SUBJECT: BROWNS FERRY NUCLEAR PLANT UNITS 2 AND 3, RELIEF REQUESTS
2-ISI-10 AND 3-ISI-9, ALTERNATIVES FOR EXAMINATION OF
INACCESSIBLE REACTOR PRESSURE VESSEL SUPPORT SKIRT WELDS
(TAC NOS. MA6408 AND MA8423)

SAFETY EVALUATION BY THE OFFICE OF NUCLEAR REACTOR REGULATION
USE OF ALTERNATIVE TO CERTAIN SURFACE INSPECTION REQUIREMENTS
TENNESSEE VALLEY AUTHORITY
BROWNS FERRY NUCLEAR POWER PLANT, UNITS 2 AND 3
DOCKET NOS. 50-260 AND 50-296

FIGURE 1

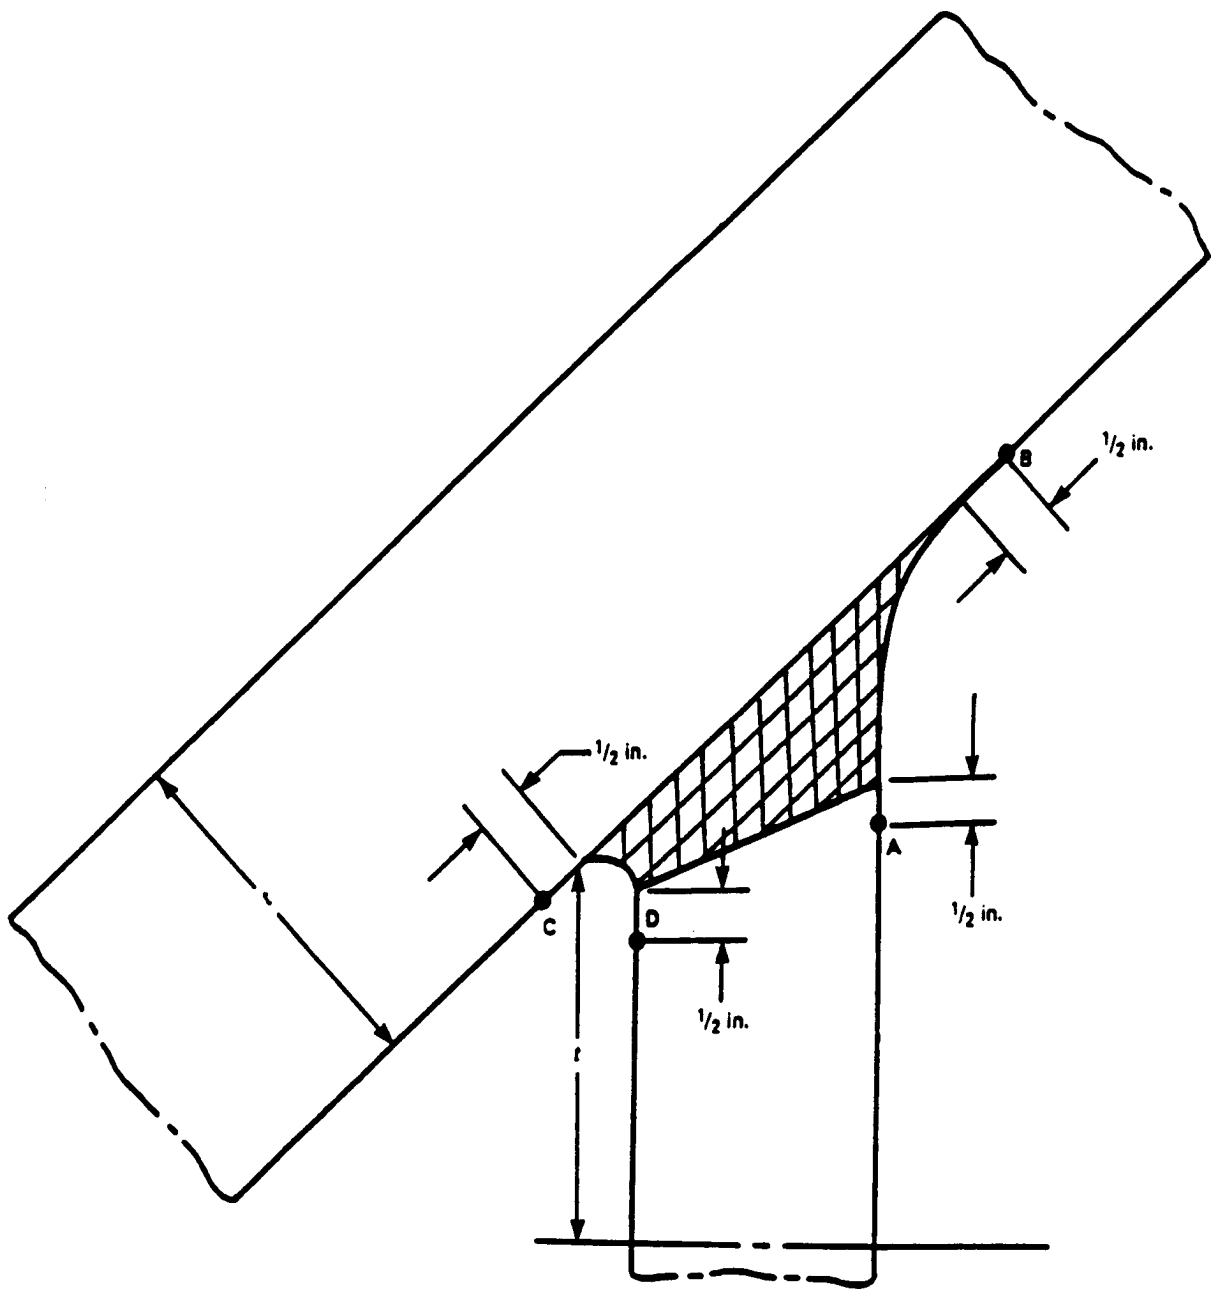
The reactor pressure vessels (RPVs) at BFN are supported on cylindrical skirts that are welded to the bottom RPV heads as shown in Figure 1. The Code requires that both surfaces of the weld be examined. An examination of the outside weld surface is readily accomplished with minimal, if any, hindrance. However, examination of the inside weld surface is difficult. The only access into the skirt is through an 18-inch opening. Inside the skirt, the weld and bottom RPV head are covered by insulation. The tasks of removing this insulation, preparing the weld surface for examination, and performing the examination are hindered by limited maneuverability in the confined space within the skirt. The confined space also houses the control rod drive mechanisms (CRDMs) that are attached to the bottom RPV head. The CRDMs further contribute to the limited maneuverability. Because of these limitations, the time needed to complete an examination of the weld surface would expose inspection personnel to high radiation dosages. The licensee estimated that the total radiation to personnel involved with preparing and examining the weld surface would total 11.2 rem.

The ASME Code specifies different examination requirements for the skirt weld configurations depicted in Figures 1 and 2. The Code requires surface examinations of both the outside and inside welded surfaces for the Figure 1 configuration. The inside examination requires personnel entry to the area inside the skirt. For the Figure 2 configuration, the Code allows (1) a surface examination for the accessible side, and (2) a volumetric examination from the accessible side of the inaccessible side. This does not necessitate personnel entry to the area inside the skirt.

FIGURE 3
 (BROWNS FERRY)

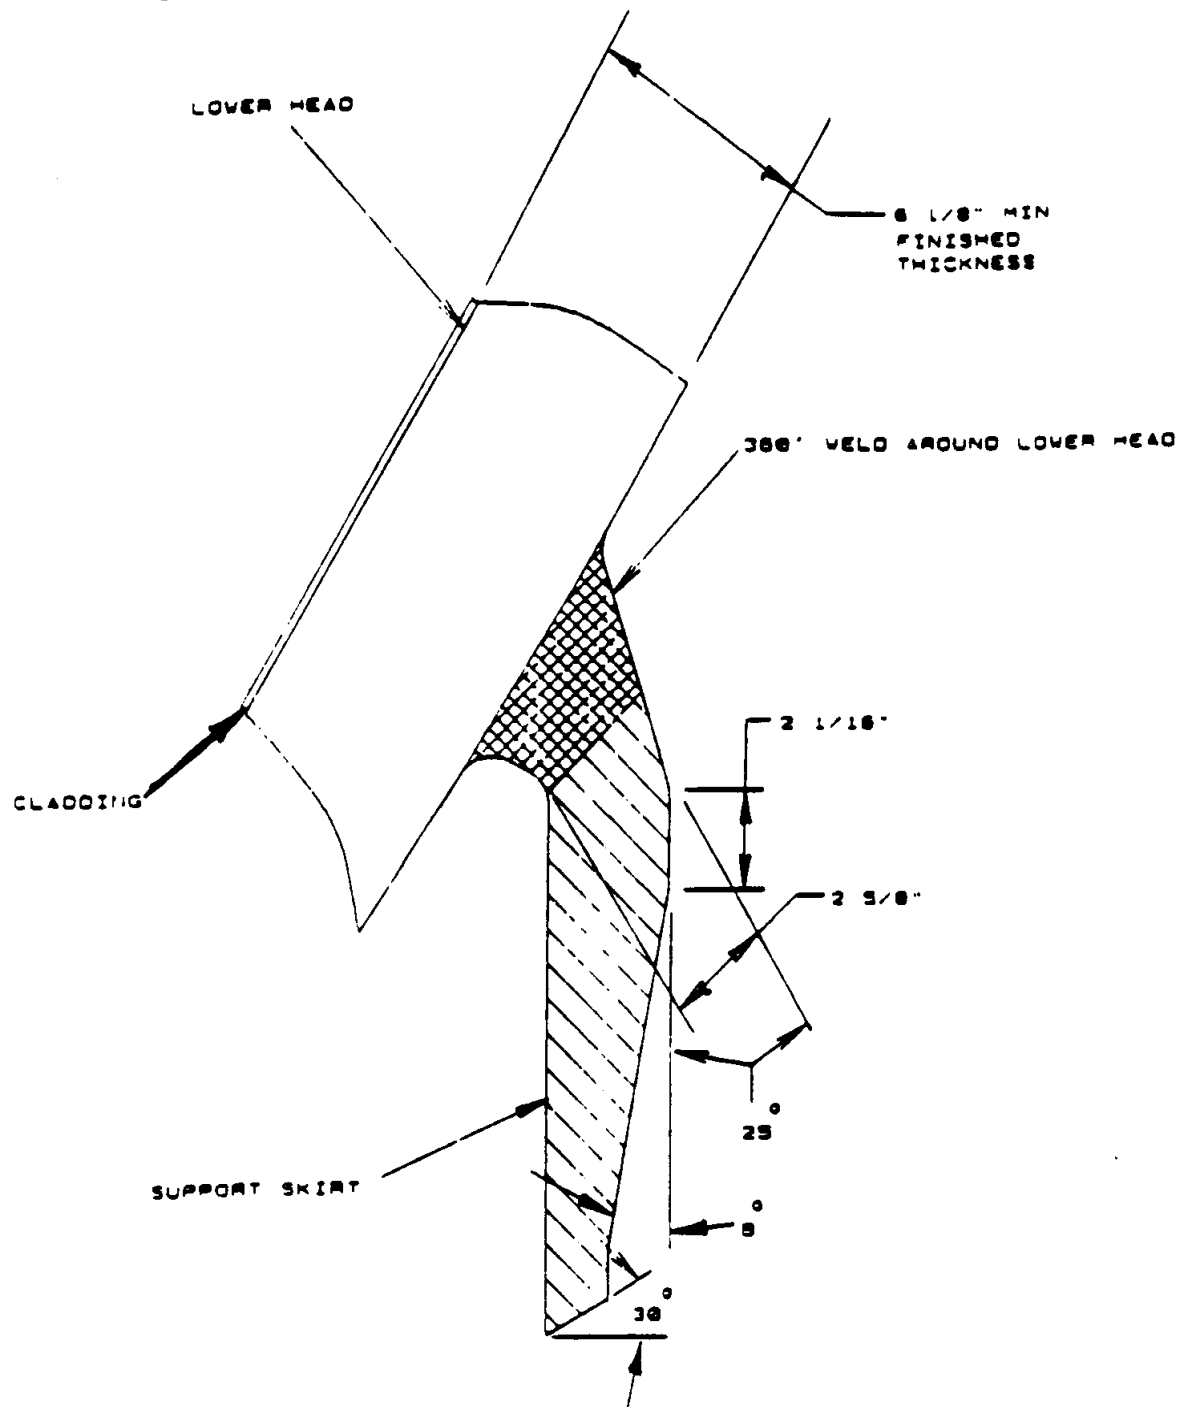
The skirt weld configuration at BFN is shown in Figure 3. This configuration is a hybrid of Figures 1 and 2. Instead of performing surface examinations from both sides of the welds in accordance with the Code requirements applicable to the Figure 1 configuration, the licensee proposes to perform (a) a surface examination on the outside surface (accessible) of the welds and, (b) a best-effort UT examination of the inside surface of the welds, from the outside surface.

This licensee's proposed alternative for its Figure 3 skirt welds is similar to the Code requirements applicable to the Figure 2 configuration. The Figure 3 configuration can, to a significant extent, be volumetrically examined from the outside surface, as is the case for the Figure 2 configuration. The weld volume capable of being examined is through wall and at or near the inside weld surface. Therefore, any crack propagating from the inside weld surface would be detectable. The staff believes that a best-effort examination, in combination with the outside surface examination of the skirt weld will provide reasonable assurance of structural integrity and an acceptable level of quality and safety.

The staff concludes that the proposed alternative described above will provide an acceptable level of quality and safety. Pursuant to 10 CFR 50.55a(a)(3)(i), the staff hereby authorizes the proposed alternative as described in Section 3.0 above. The proposed alternative is authorized by law and will not endanger life or property or the common defense and security and is otherwise in the public interest.
